**From:** John Long  
**Sent:** 10 December 2020 15:09  
**To:** Hilary Saunders  
**Subject:** Planning Ref: NYM/2020/0913/RM East of 12 Esk View Egton - revised access

**Revised Plans - Application for reserved matters (access only) following outline approval NYM/2020/0324/OU for construction of 2 no. principal residence dwellings at land east of 12 Esk View, Egton (Planning Ref: NYM/2020/0913/RM)**

ACCESS DESIGN

DRAWING No: 2008004

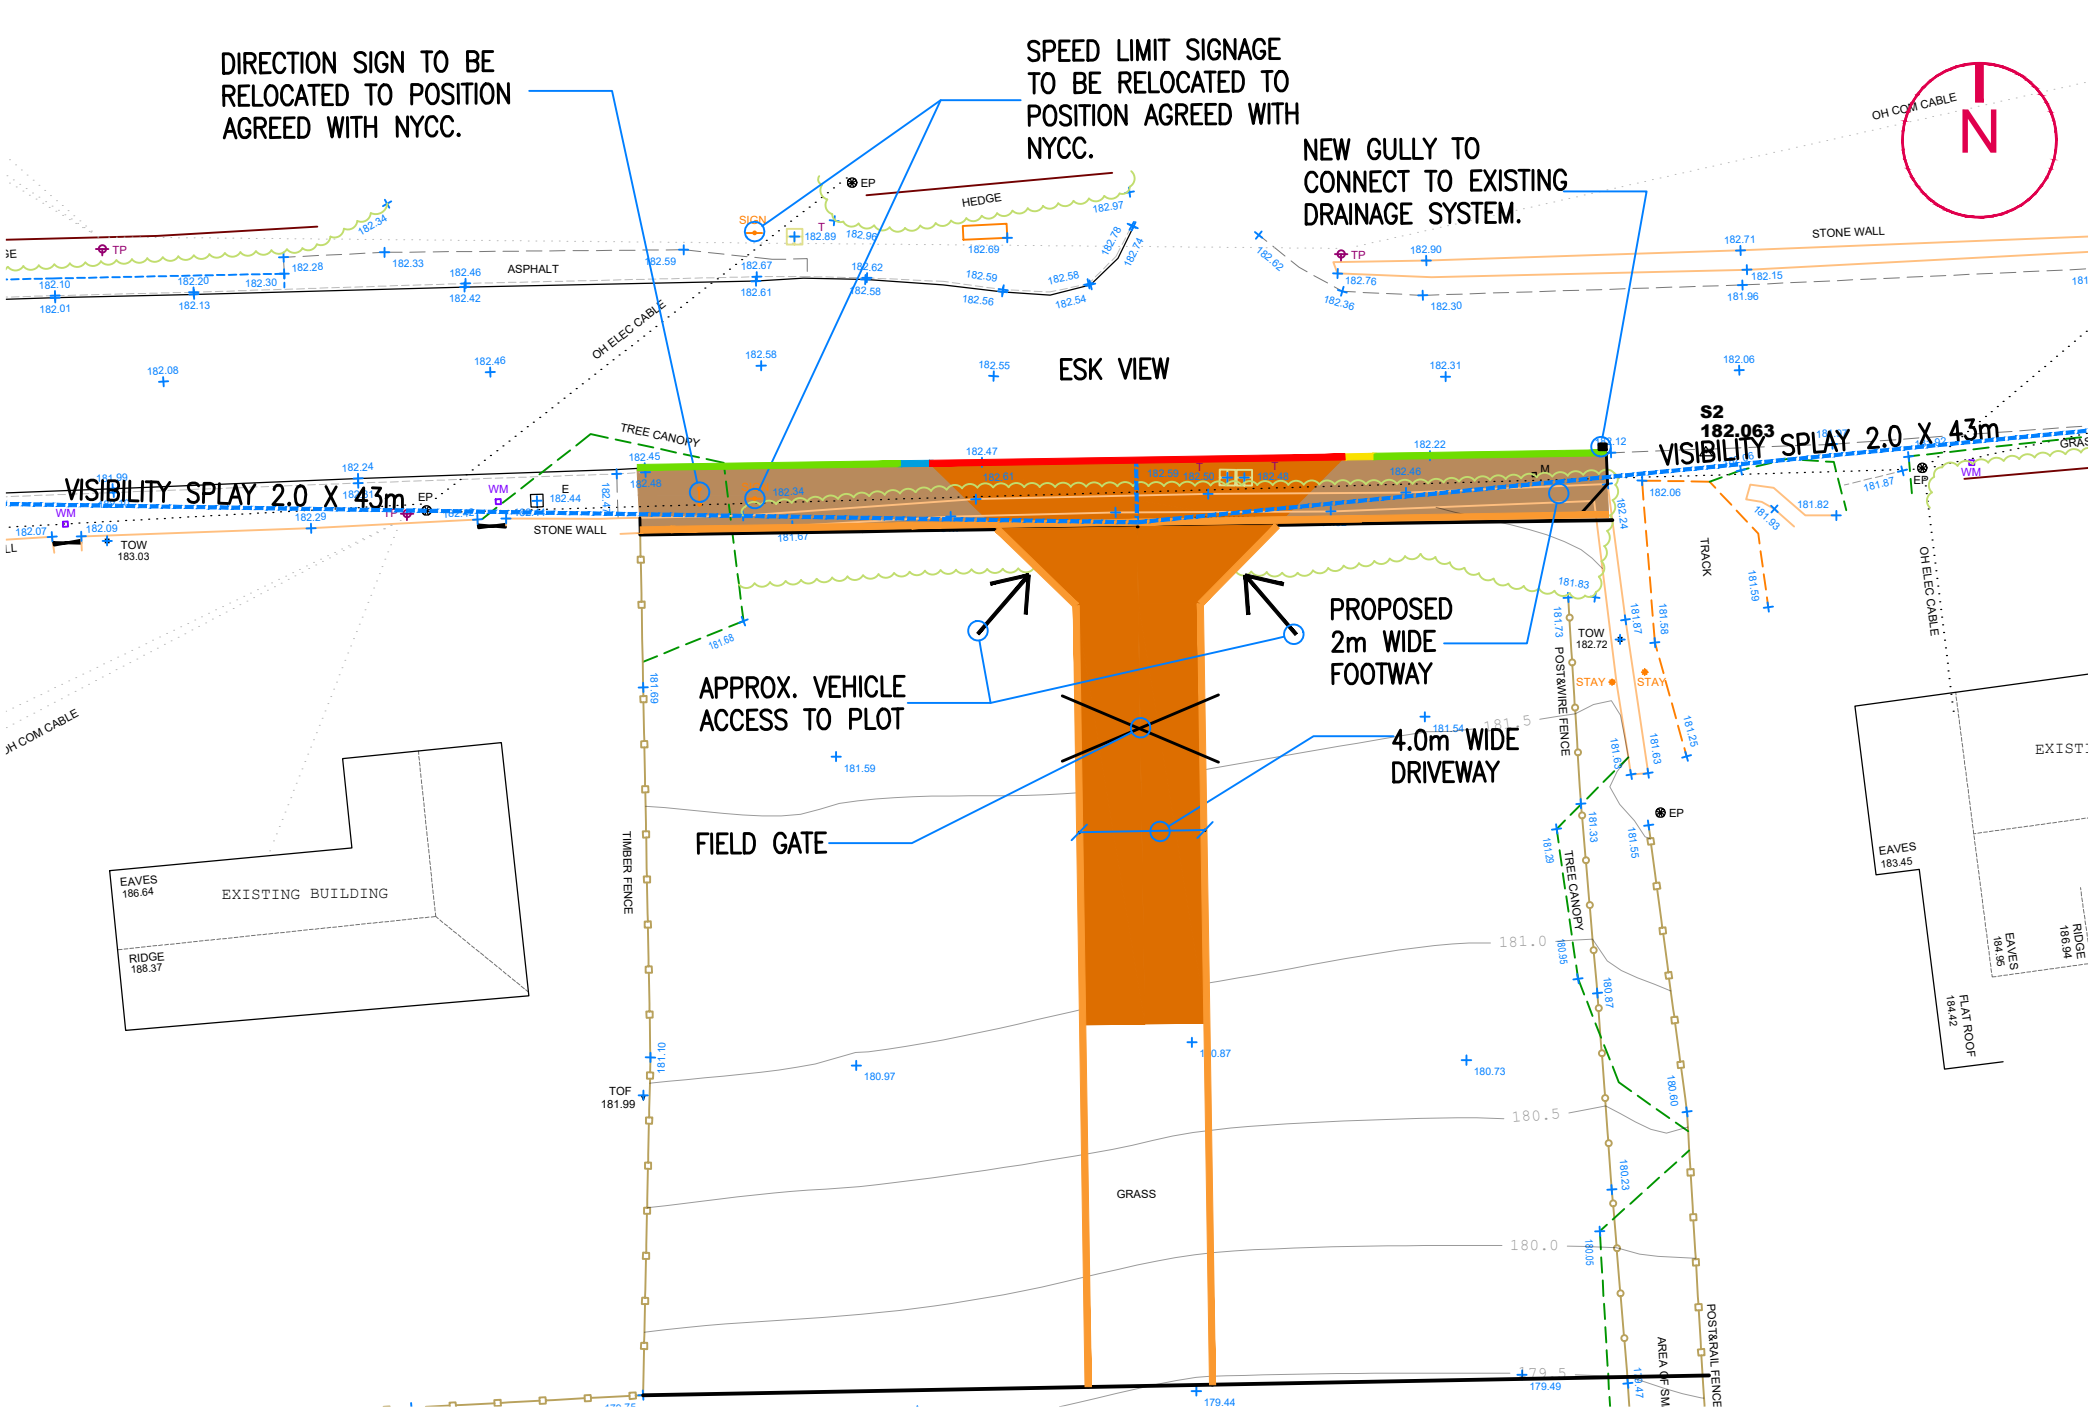
The revisions are proposed to address concerns that you have raised in your letter of the 1 December 2020 related to the urbanising effect of the originally submitted RMs scheme. The scheme has been revised to reduce the extent/width of the access and provide separate access into each property with their own private drive, and also access to the field to the rear for agricultural vehicles.

You will appreciate that the location of the accesses needs to address condition 14 of the outline consent in terms of achieving the necessary visibility splays, the implication of which requires the accesses to be centrally located. The revised drawing shows that the required visibility splays can be achieved. Also, the access needs to be sufficiently wide to allow for the swept path of a farm vehicle and trailer using it. Unfortunately, the indicative access arrangements as shown on the outline scheme would not meet the outline consent condition requirements.

I attached the revised access plan(ref: 2008004 Rev A).
